# Fosse Green Energy

EN010154

9.12 Solar Technology Technical Guide

#### 9.12 Solar Technology Technical Guide

**Figure 5-1 - Typical solar module degradation curve**

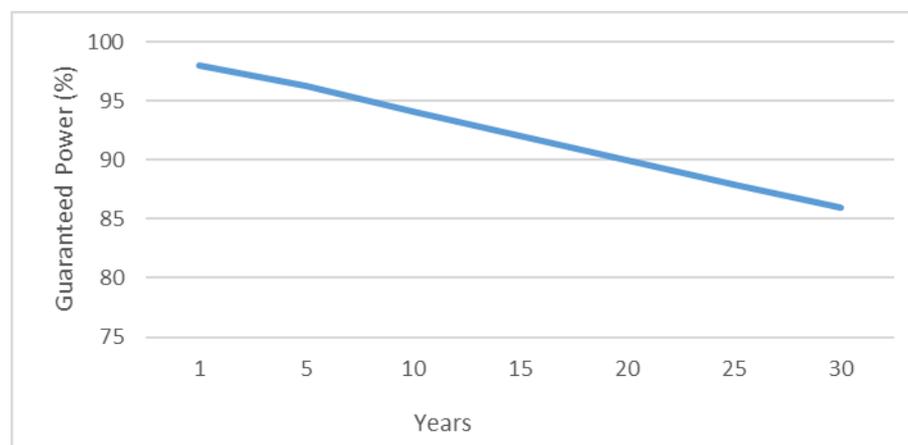
<b>Written Question</b>	<b>Technical Guide Signpost</b>
<p><b>GC 1.06 - Solar panel performance degradation</b></p> <p>In paragraph 6.4.67 of Chapter 6 (Climate Change) of the Environmental Statement (ES) [APP-031] an explanation for the expected degradation rate for the solar panels (modules) to be installed as part of the proposed development is given, namely 2% for year one of the proposed development and then 0.45% for each year between year 2 and year 30. It being envisaged that the originally installed modules would be replaced from year 31 onwards.</p> <p>a) For a solar module with a generating capacity of 670 watts (the illustrative design referred to in paragraph 3.3.6 of Chapter 3 of the ES [APP-028]) provide a worked calculation for the performance degradation for the solar module for each year of its anticipated 30 year life, assuming 2% degradation in year one and 0.45% degradation in each of the subsequent years through to year 30.</p> <p>b) Explain what accounts for a 2% reduction in panel performance in year one relative to a 0.45% reduction in performance in subsequent years. Clarify whether with the assumed panel replacement from year 31 onwards it would be correct to apply a performance degradation factor of 0.45% for year 31 and all subsequent years or whether a higher factor should be applied to year 31 and then 0.45% in all subsequent years.</p>	<p>Part a – Section 5.2</p> <p>Part b – Section 11</p>

- 5.2.1 Solar module degradation is higher in the first year (~2%) due to Light-Induced Degradation (LID), which is caused by a module's first exposure to sunlight after being manufactured. Each year after this, the modules can be expected to degrade at a rate of approximately 0.45% per year per the module datasheet used for the indicative layouts, assuming an appropriate and consistent maintenance regime over the module's operating life (assumed to be 30 years). These assumptions result in a module power output after 30 years of approximately 87% of the original rated power output. Once modules are replaced in year 31, they will undergo the same 1-2% LID in year 31 followed by 0.45%/year for the remainder of their lifetime.

- 11.3.2 Assuming panel replacement in Year 31, there would be an initial 2% LID for the first year with 0.45% thereafter. This would match the Year 1-30 degradation chart provided in Figure 5-1. Again, this could improve with newer technology after another 30 years of solar module development and continued improvements in construction, maintenance and monitoring of modules.
